**CITY OF SAINT PAUL
HERITAGE PRESERVATION COMMISSION STAFF REPORT**

FILE NAME: 882 West Seventh Street
INVENTORY NUMBER: RA-SPC-2937
APPLICANT: Craig Cohen
ARCHITECT: Jerry Hagen, Hagen Christensen & McIlwain Architects
DATE OF PUBLIC HEARING: June 14, 2018
HPC SITE/DISTRICT: Jacob Schmidt Brewing Company Historic District
PERIOD OF SIGNIFICANCE: 1858-1955
CATEGORY: Contributing **WARD:** 2 **DISTRICT COUNCIL:** 9
ZONING: T3 **CLASSIFICATION:** Addition
STAFF INVESTIGATION AND REPORT: George Gause

sheet title
SITE PLAN AND RAISED DECK
DETAILS

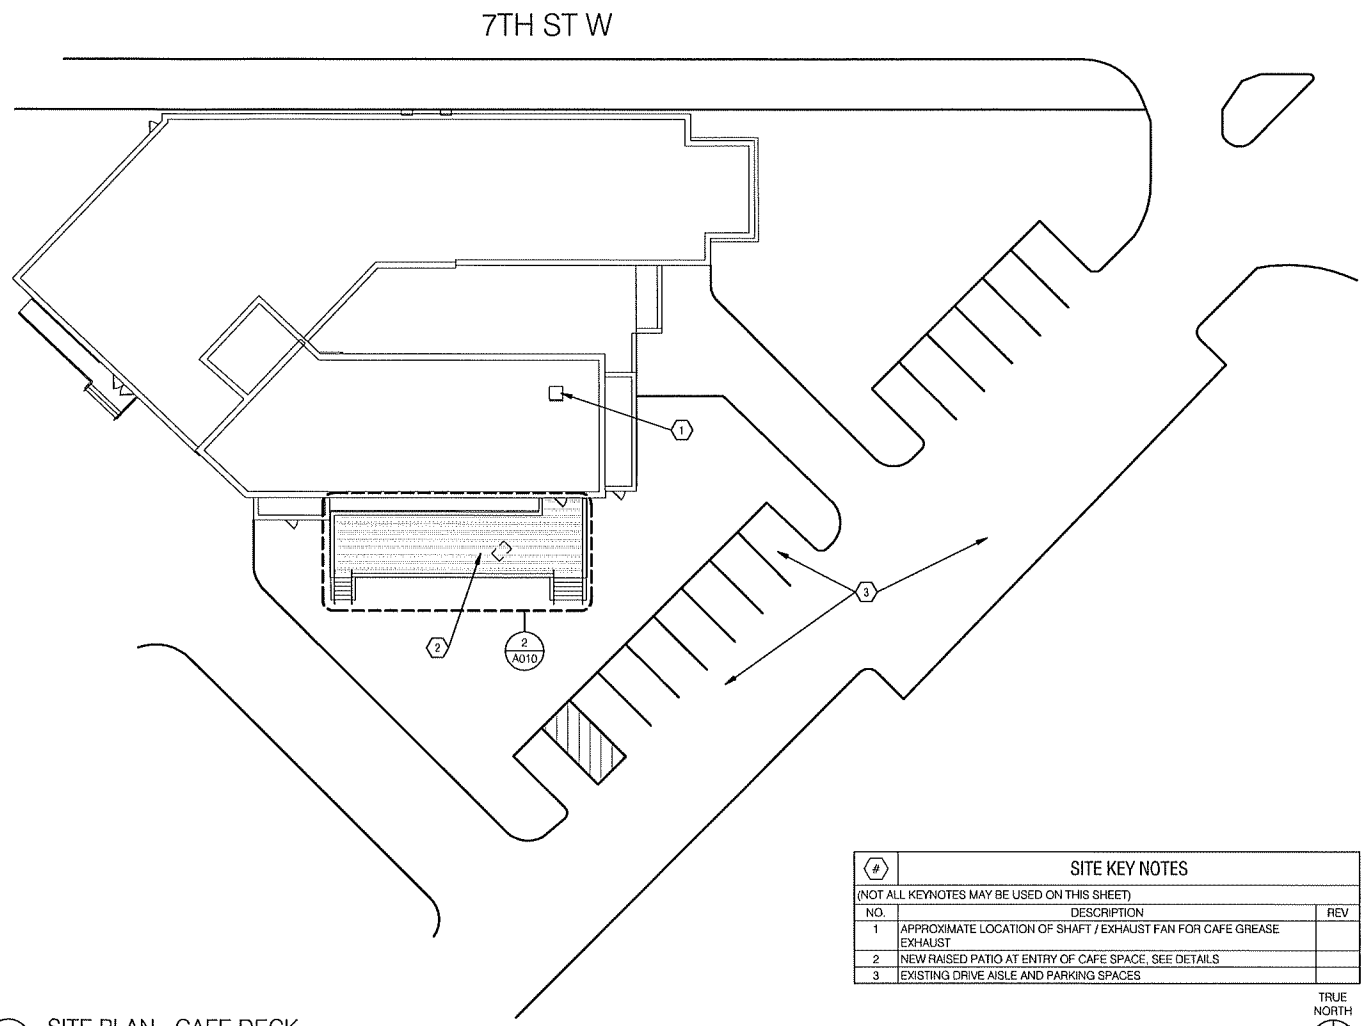
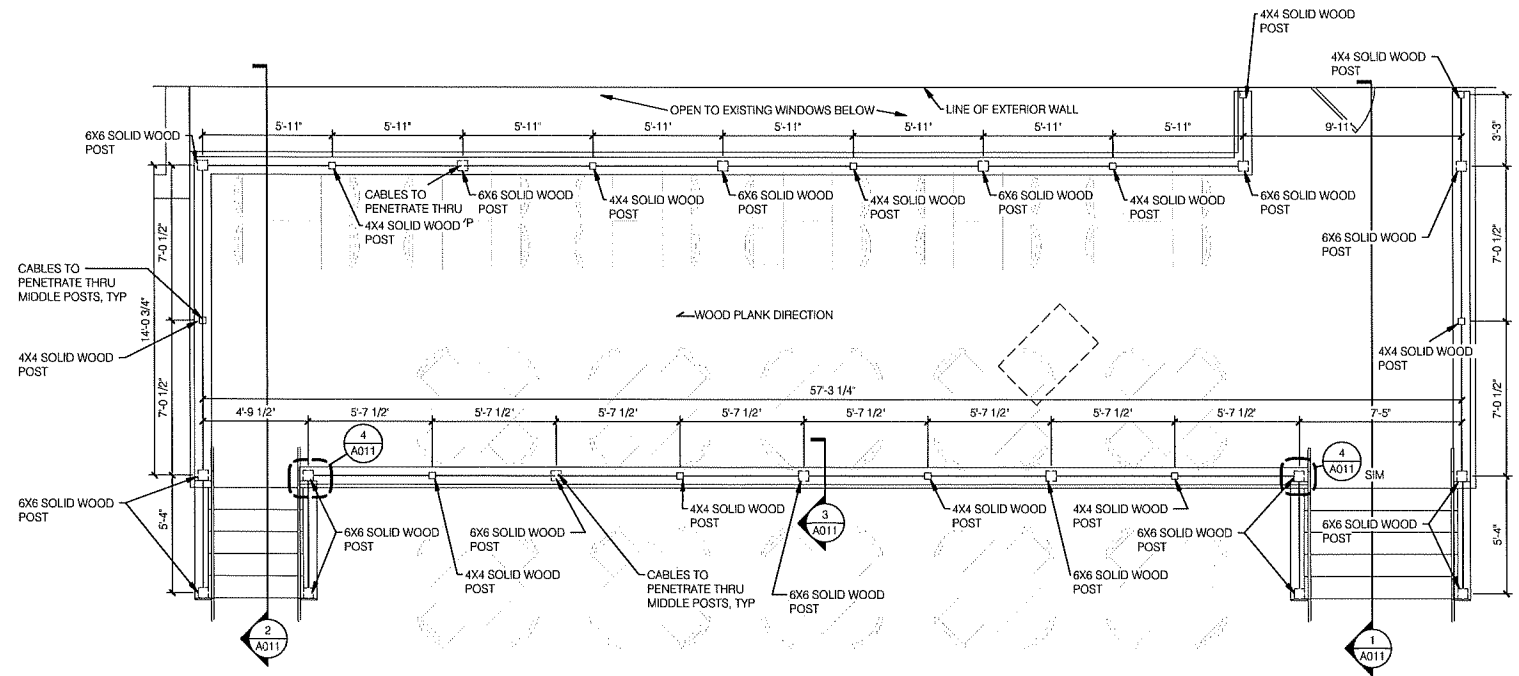
Deck: The applicant proposes to construct a wood deck to the rear of the Jacob Schmidt office building. This deck will provide an outdoor patio space for the first level restaurant space (Rose Street Patisserie). The deck will be raised to the same level as the first floor of the office building which is approximately 3 ½'. The deck will bridge to the building at the northeastern door. Overall deck will be 14' x 58', wood plank flooring and feature stainless steel tensioned cable baluster railing. The entire deck will be set back from the building approximately 3 ½'. The deck will not be visible from the public right-of-way.

for ADA access to the building.
<i>10. New additions and adjacent or related new construction will be undertaken in such a manner that, if removed in the future, the essential form and integrity of the historic property and its environment would be unimpaired.</i>	Yes	Proposed deck will be sited away from the rear facade, preserving the form and integrity of the structure and could be easily removable in the future.

Guideline	Meets Guideline?	Comments
(4) Existing structures and building a. Exterior Surfaces. <i>Decks and fire stairs: Deck and fire stair additions and new balconies may be acceptable in some cases, but should be kept to the rear of buildings where they will be the most inconspicuous and detract the least from the historical context. The detailing of decks and exterior stairs should be compatible with the period and style of the building.</i>	Yes	Proposed deck is located at the rear of the structure and will be mostly inconspicuous.

4. *Exterior Surfaces.* The proposal to construct a rear deck, which will be sited away from the rear facade, preserving the form and integrity of the structure and easily removable in the future is compliant with the Preservation Program for Jacob Schmidt Brewing Company Heritage District.

**GC TO PROVIDE ALT DEDUCT FOR STAIR AND MINIMAL PLATFORM AT ENTRY DOOR IN LIEU OF RAISED DECK

1 OVERALL FIRST FLOOR PLAN
SCALE: 1/8" = 1'-0"

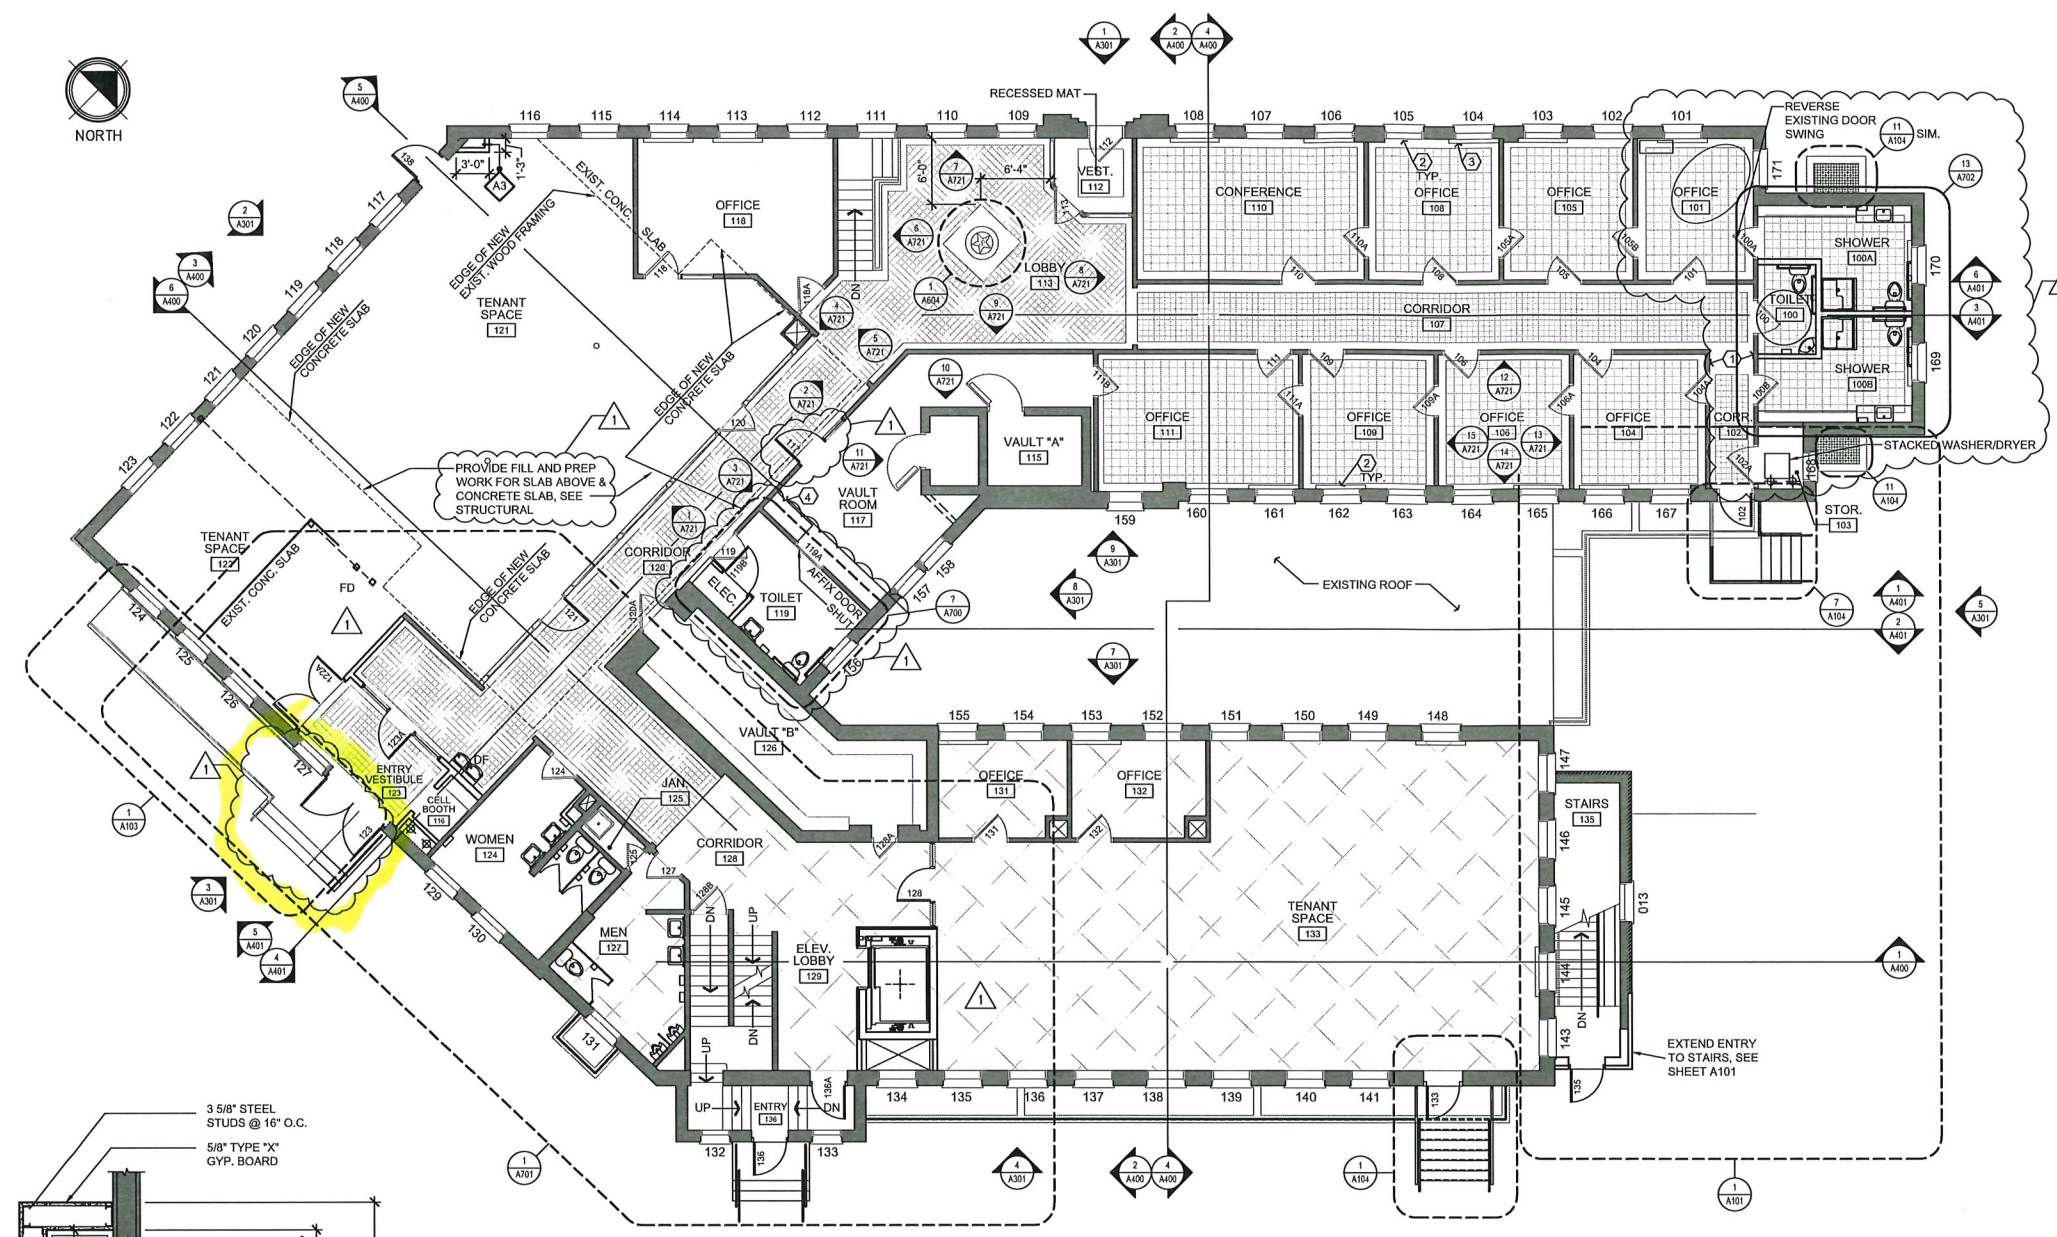
Door: An expansion of the rear door from a single door to a double door on the south façade is needed to accommodate the adaptive reuse of the structure. A larger entry is required for deliveries and ADA access (adjacent to ADA parking) to the proposed restaurant spaces. The door is on the rear façade and would not be visible from the public right-of-way. The opening will be configured to be compatible with other openings on the structure. The stoop with railing would be slightly expanded to accommodate the larger door opening. All materials of the stoop will match the existing.

(4) Existing structures and building e. Windows and doors. <i>Openings: Infilling of window openings or installing new openings may be permissible on secondary facades if standard sizes approximate the size and proportions of the opening.</i>	Yes	The door alteration is located on the rear facade of the structure. The new opening will be proportionate to the existing doors/windows.

(4) Existing structures and building e. Windows and doors. <i>Solid to void ratio: New openings may be acceptable on secondary or minimally visible elevations so long as they do not destroy or alter any architectural features and the size and placement is in keeping with the solid-to-void (wall-to-openings) ratio of the elevation.</i>	Yes	The door alteration is located on the rear facade of the structure. This facade is not visible from the public right-of-way. No architectural features will be altered or removed.

5. *Existing structures and building-windows and doors.* The alteration of a single door to a double door is on a secondary façade.
6. The proposal to construct a rear deck, door expansion and mechanical installation at 882 West 7th Street will not adversely affect the Program for the Preservation and architectural control of the Jacob Schmidt Brewing Company Heritage Preservation District (Leg. Code §73.06 (e)) so long as the conditions are met.

- Provide wainscot infill to match existing adjacent.
- Existing radiator cover to be removed, repainted, & reinstalled -typ. north wing.
- Provide new radiator cover at existing opening (cover missing) to match existing adjacent.
- Provide new oak transaction counter top to replace demolished plastic laminate counter top.
- Extend existing stoop, steps & footings to allow for double door inside
